Sheet: /
File: 2n2-trans.sch
Title: 2N2-40 Receiver
Size: A
Date: 12/22/2019
KiCad E.D.A. kicad (5.1.2)-2
Rev: V01
Id: 1/2
Sheet: Sheet5F479ABD
File: 2n2-40-audio.sch
J1
Conn_01x15_Female
J3
Conn_01x15_Female
A1
Arduino_Nano_v3.x
U2
Nokia5110
U1
OLED-096
U3
si5351-module
U4A
74HCOO
U4B
74HCOO
U4C
74HCOO
U4D
74HCOO
U4E
74HCOO
J8
Power In
J2
Power out
1n5817
D100
C200

Sheet: Sheet5F479ABD
File: 2n2-40-audio.sch
Final Manufactured 7/20
Analog
Mike M. KU4QO
Sheet: /
File: 2n2-trans.sch
Title: 2N2-40 Receiver
Size: A
Date: 12/22/2019
KiCad E.D.A. kicad (5.1.2)-2
Rev: V01
Id: 1/2

Digital

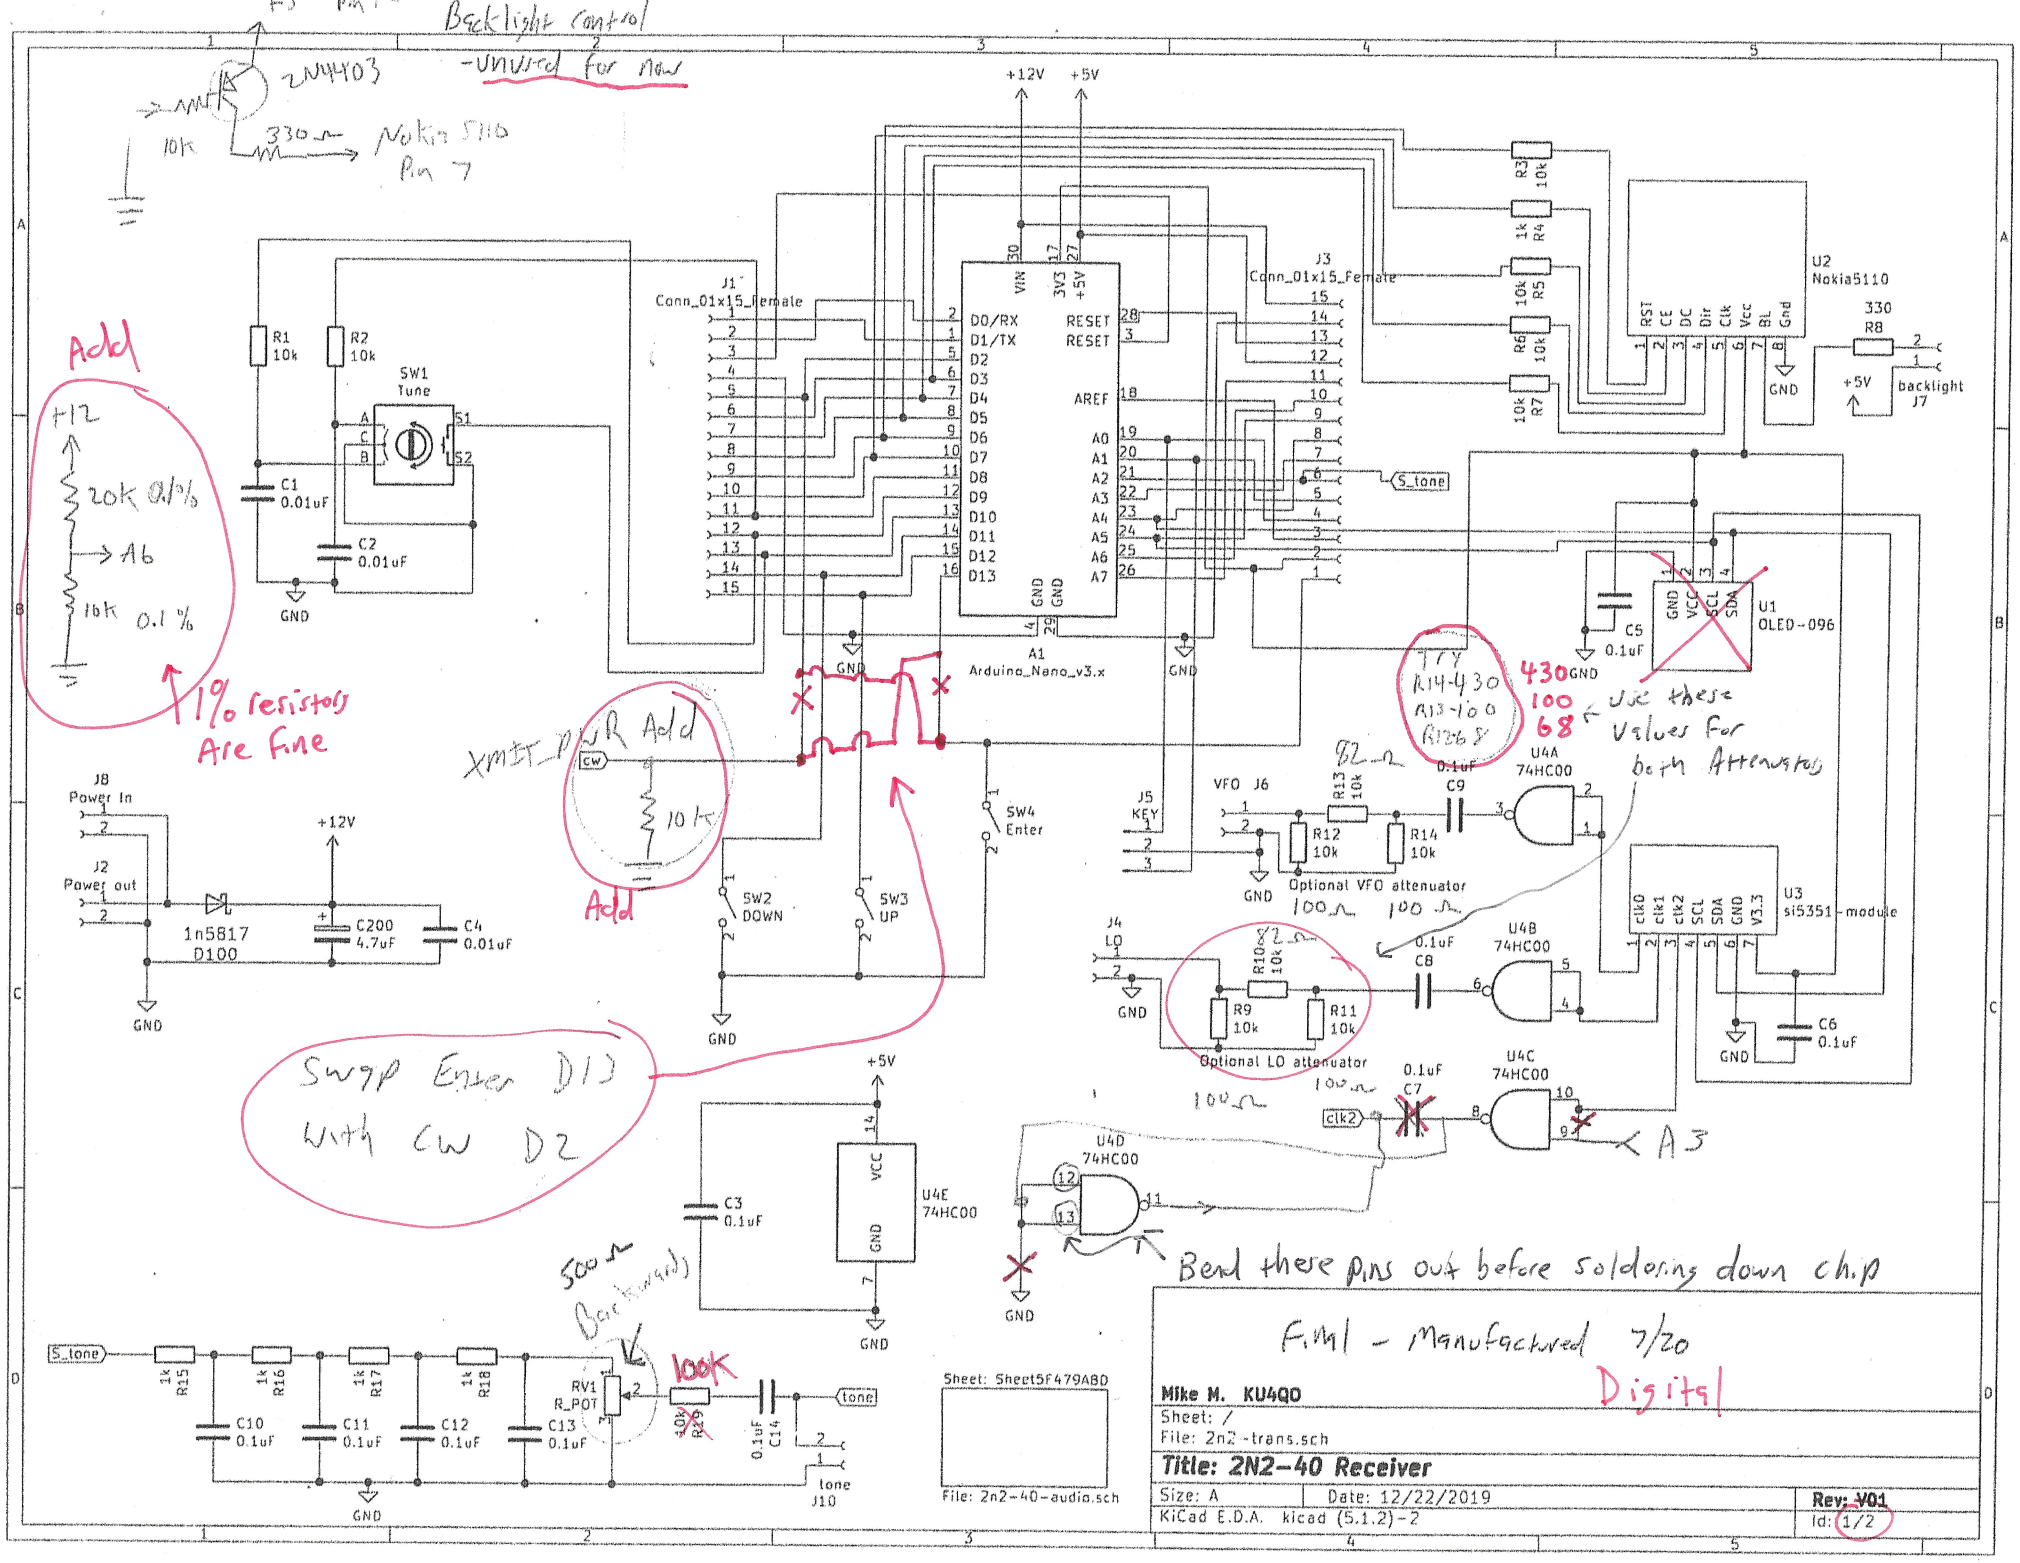
Backlight control
-unused for now
2N4403
10k
330
Nokia 5110
Pin 7
Add
+12
20k 0.1%
A6
10k 0.1 %
1% resistors
Are fine
XMIT_PWR Add
CW
10 k
Add
Swap Enter D13
with CW D2
Try
R14-430
R13-100
R12-68
430
100
68
use these
values for
both Attenuators
Bend these pins out before soldering down chip
Final - Manufactured 7/20
Digital
Mike M. KU4QO

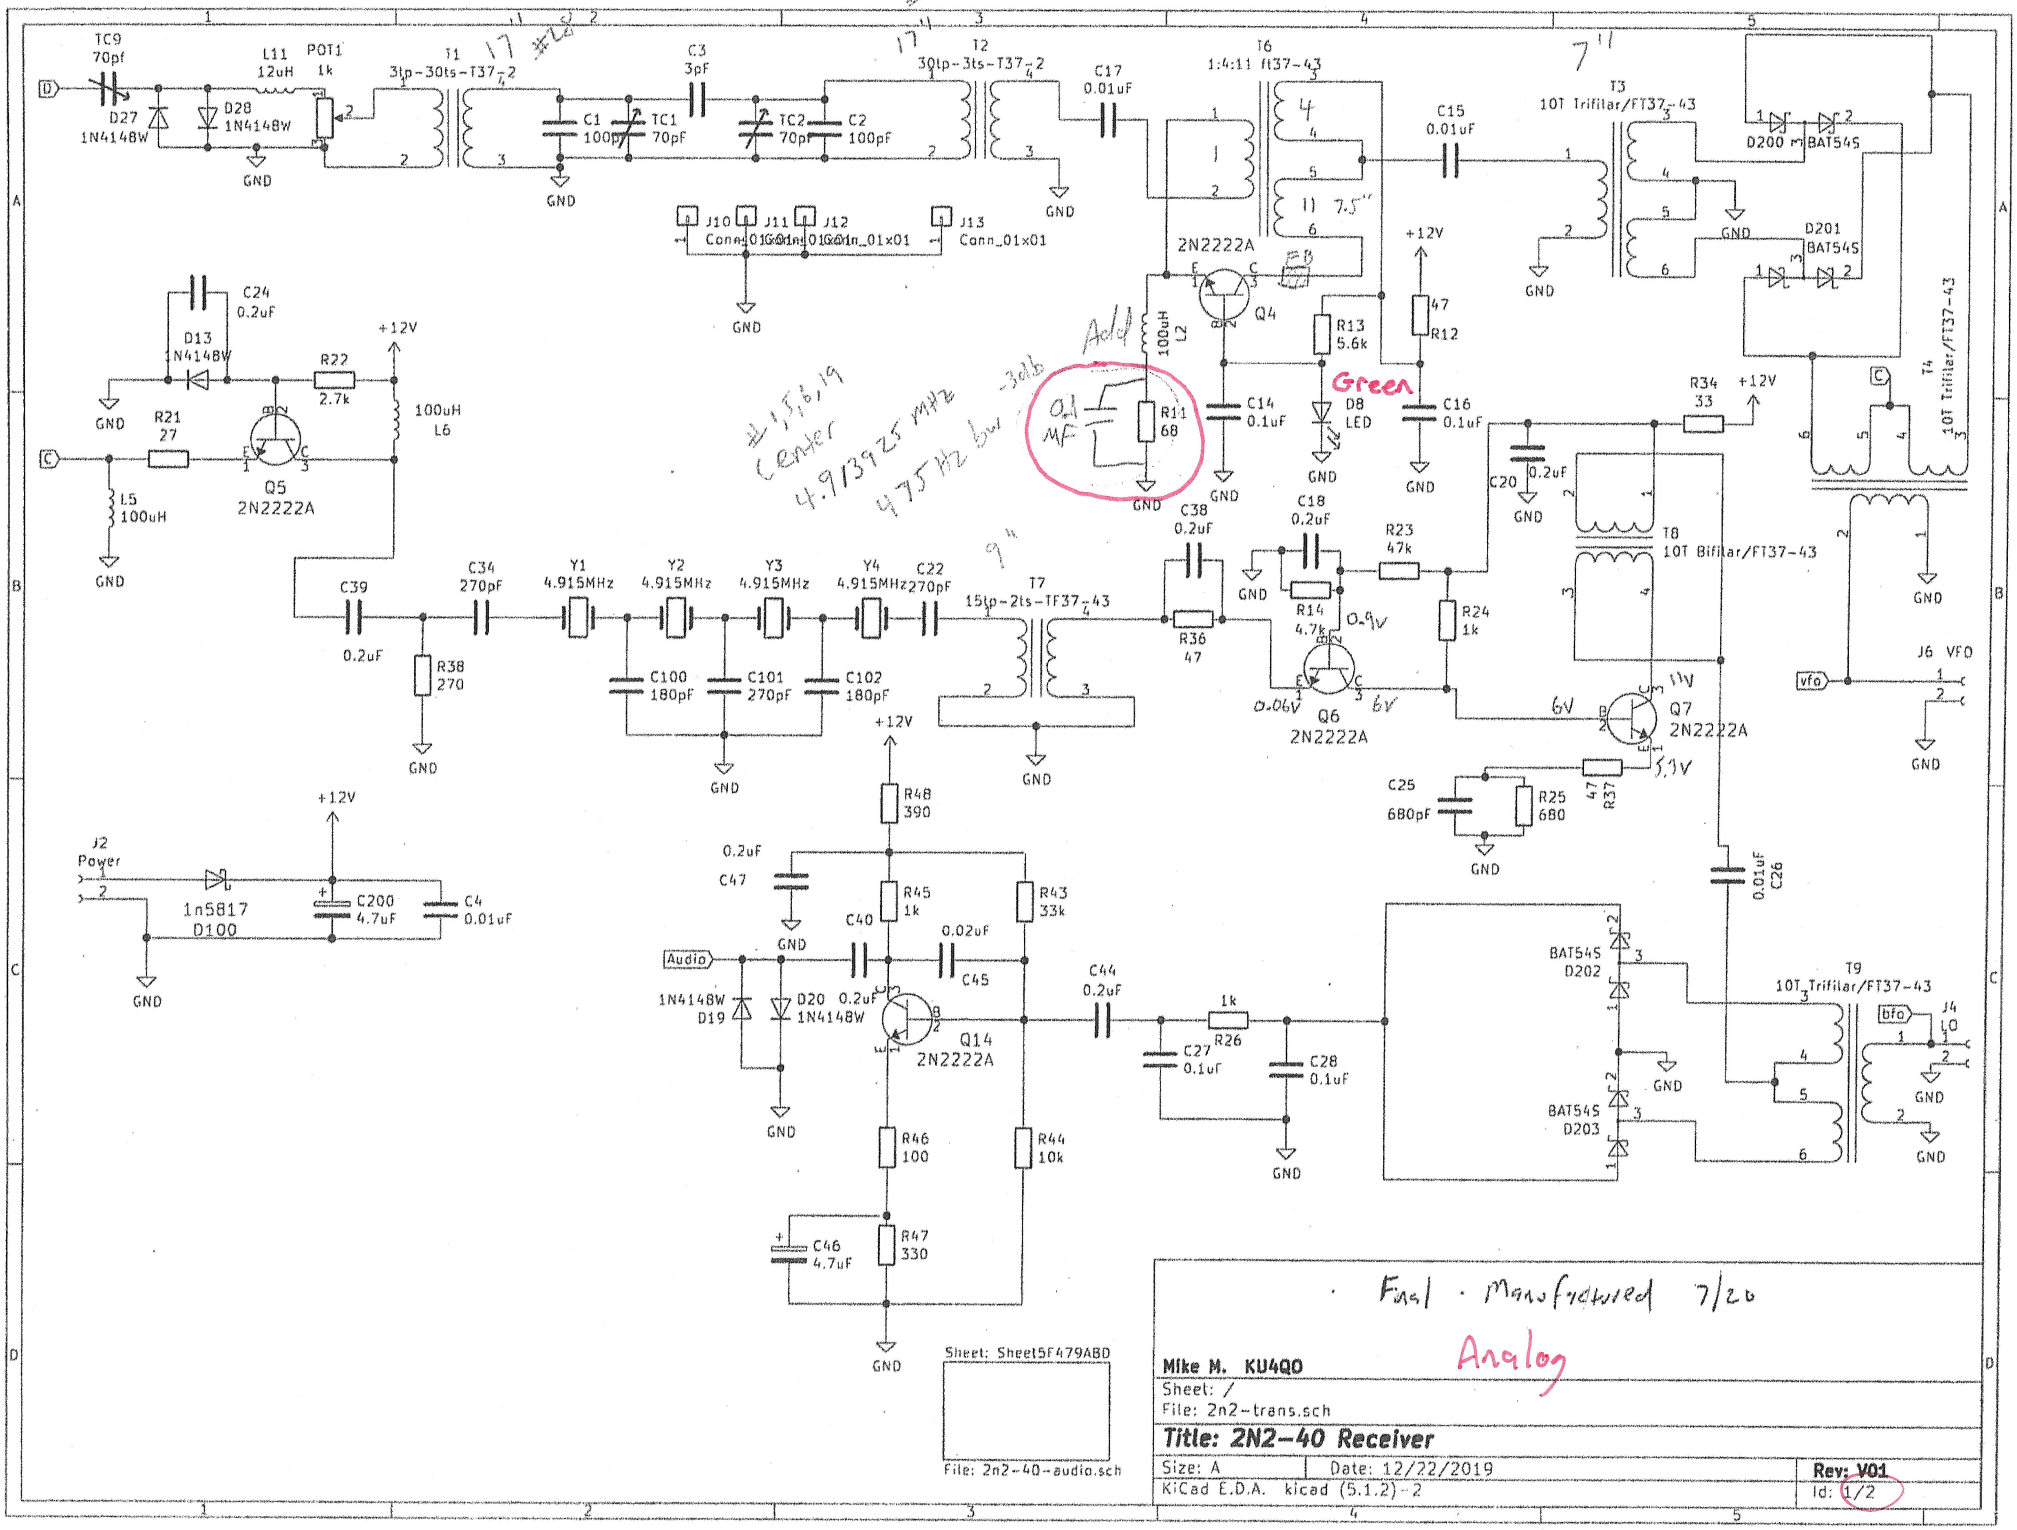
TC9 70pf
D27 1N4148W
D28 1N4148W
L11 12uH
POT1 1k
T1 3tp-30ts-T37-2
C1 100pF
TC1 70pF
C3 3pF
TC2 70pF
C2 100pF
T2 30tp-3ts-T37-2
C17 0.01uF
T6 1:4:11 ft37-43
C15 0.01uF
T3 10T Trifilar/FT37-43
D200 BAT54S
D201 BAT54S
T4 10T Trifilar/FT37-43
J10 Conn_01x01
J11 Conn_01x01
J12 Conn_01x01
J13 Conn_01x01
2N2222A
Q4
R13 5.6k
R12 47
D8 LED
Green
C14 0.1uF
C16 0.1uF
100uH L2
R11 68
Add 0.1 uF
C24 0.2uF
D13 1N4148W
R22 2.7k
R21 27
L5 100uH
Q5 2N2222A
100uH L6

#15,16,19 Center 4.913925 mHz 4.75 Hz bw -3db
R34 33
C20 0.2uF
T8 10T Bifilar/FT37-43
C38 0.2uF
C18 0.2uF
R23 47k
R14 4.7k
R36 47
R24 1k
Q6 2N2222A
Q7 2N2222A
C25 680pF
R25 680
R37 47
C39 0.2uF
C34 270pF
Y1 4.915MHz
Y2 4.915MHz
Y3 4.915MHz
Y4 4.915MHz
C22 270pF
T7 15tp-2ts-TF37-43
R38 270
C100 180pF
C101 270pF
C102 180pF
J6 VFO
J2 Power
1n5817 D100
C200 4.7uF
C4 0.01uF
R48 390
C47 0.2uF
R45 1k
R43 33k
C40
C45 0.02uF
Audio
1N4148W D19
D20 1N4148W
Q14 2N2222A
C44 0.2uF
R26 1k
C27 0.1uF
C28 0.1uF
R46 100
R44 10k
C46 4.7uF
R47 330
C26 0.01uF
BAT54S D202
BAT54S D203
T9 10T Trifilar/FT37-43
J4 LO

Analog

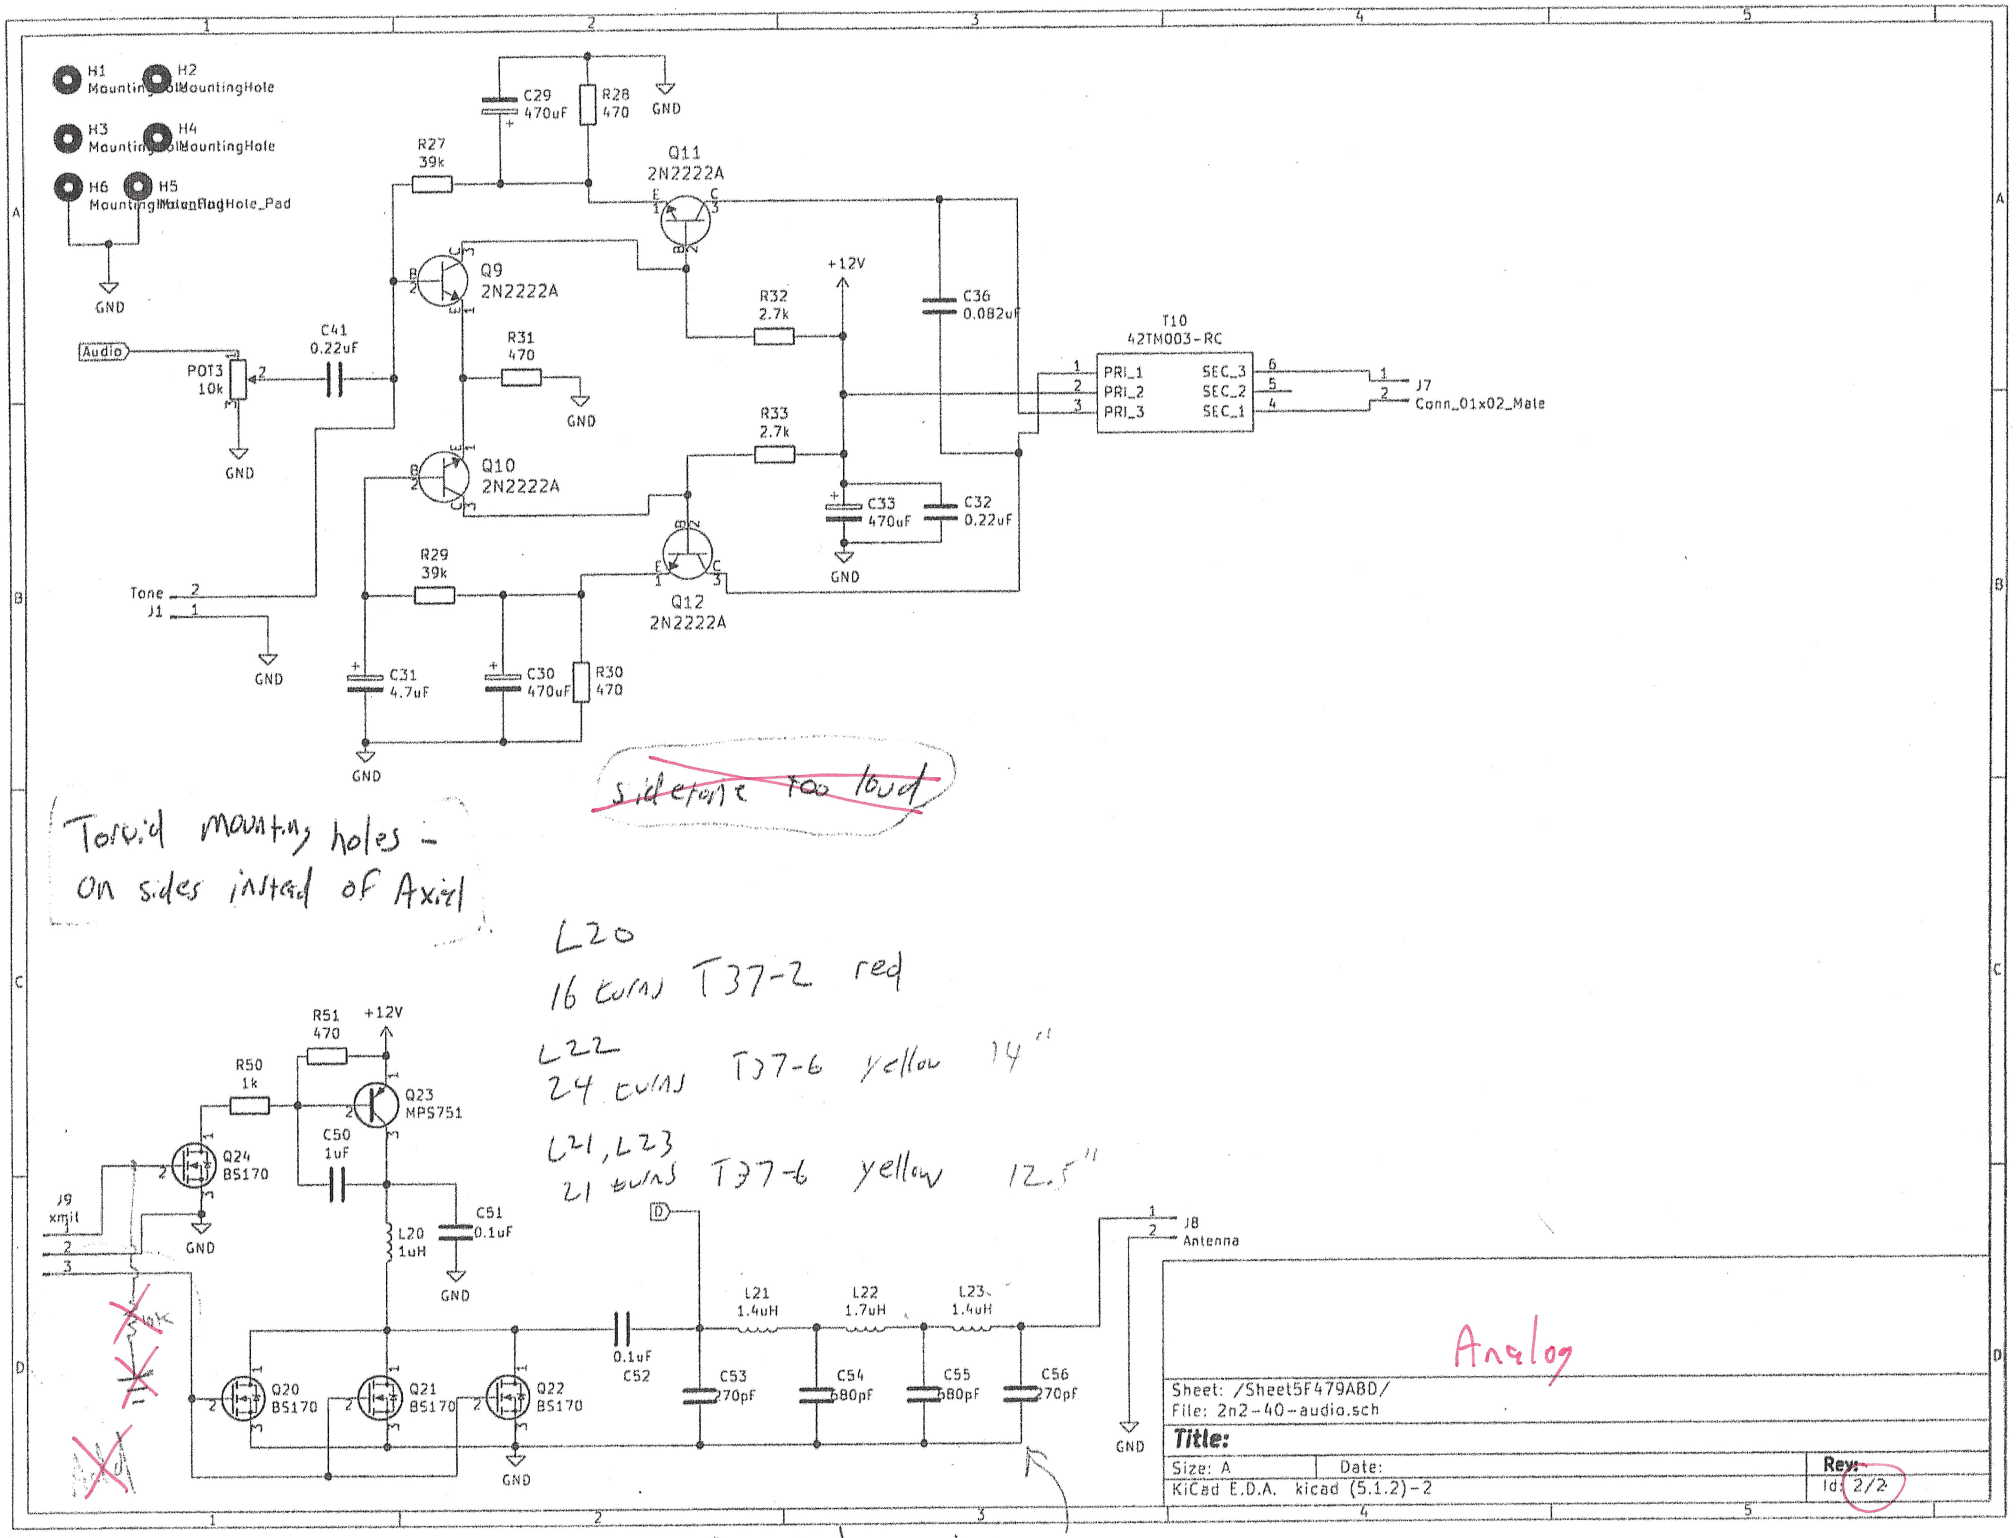
~~sidetone too loud~~

Toroid mounting holes - on sides instead of Axial

L20
16 turns T37-2 red

L22
24 turns T37-6 yellow 14"

L21, L23
21 turns T37-6 yellow 12.5"

Low inductor holes
